Service Technical Information -

NSX-SZ50 / SZ52 / BL54 / BL56

Poping sound from the speaker during POWER ON

<u>REF.No.</u> :G – A0 – 007 – E0

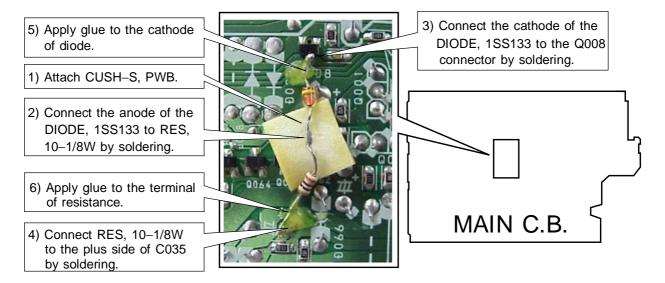
It is reported that when power is turned on with ECO on, a momentary poping sound may comes out from the speakers.

- 1) Attach CUSH-S, PWB.
- 2) Connect the anode of the DIODE, 1SS133 to RES, 10-1/8W by soldering.
- 3) Connect the cathode of the DIODE, 1SS133 to the Q008 connector by soldering.
- 4) Connect RES, 10–1/8W to the plus side of C035 by soldering.
- 5) Apply glue to the cathode of diode.
- 6) Apply glue to the terminal of resistance.
